# SB-10032406-3849

Bulletin No.: PIT4898B

**Subject:** The Drivers Power Seat Inoperative or SIR Light Is On With DTC's B0014 B0015  
**Models:** 2010 Chevrolet Equinox

2321545

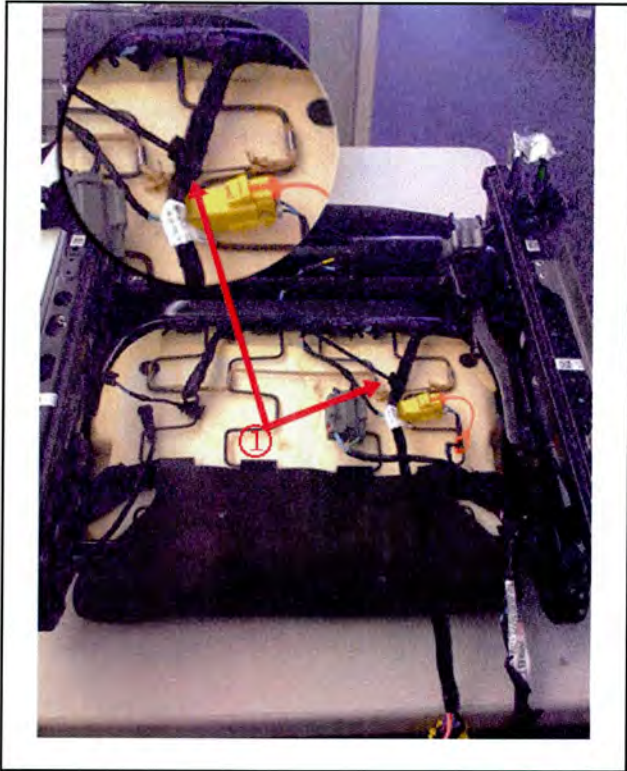
In rare cases, customers may complain that the driver's power seat is inoperative and/or the SIR light is coming on intermittently. When diagnosing the vehicle, DTC's B0014 and/or B0015 may be found in the SDM. The "PWR SEAT LT" fuse may be open in the under hood fuse block. This may be caused by a wire harness getting pinched under the driver's seat, between the seat frame and the power seat motor (see picture above). This concern happens when the seat is moved to the up position. This is applicable for both 4 and 8 way power seats.

2462212

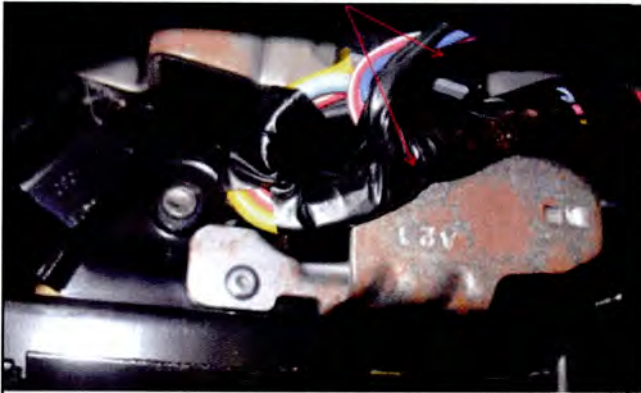
Check the wire harness under the seat for contact between the seat frame and the power seat motor. Picture shown is viewing the driver's seat from underneath. If any wires are found to be damaged, repair them as necessary. Before performing operation, move seat to most up (vertical) and most forward (horizontal) position to ensure harness will be in correct position. To prevent any further contact of wire harness and seat frame use a tie strap to secure harness to the 1st position of the seat cushion retainer as shown in picture. This will keep the harness clear of being trapped. Cut the excess length of the tie strap after securing harness bundle to suspension/wire frame.

2526551

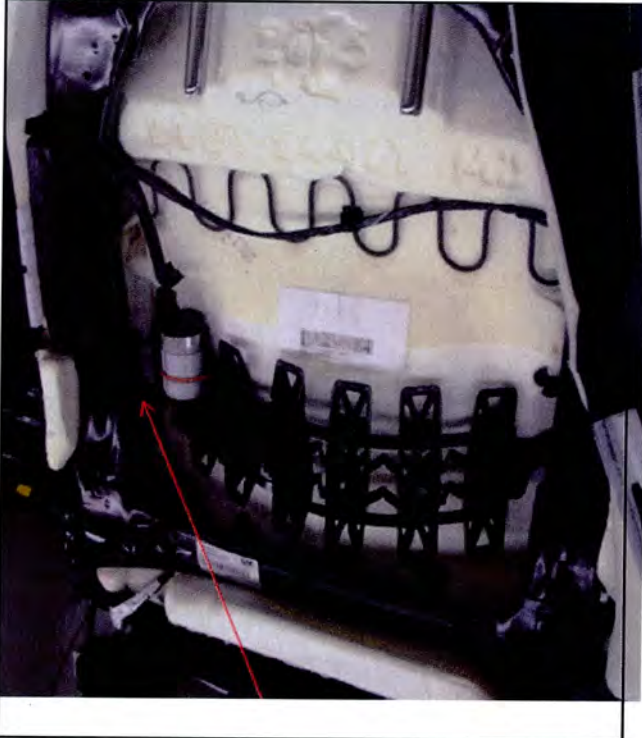
On vehicles equipped with 4 way seats, drivers side seat wiring to switch can become pinched and or chafe on side shield bracket. This can add more pressure from the harness to the seat switch and damage the seat switch. This condition occurs when the seat is in the full down position.

Add abrasion tape, mastic patch or equivalent over bracket to protect harness. Adding abrasion tape or conduit will cause harness to be too stiff and will aggravate wire to switch issues.
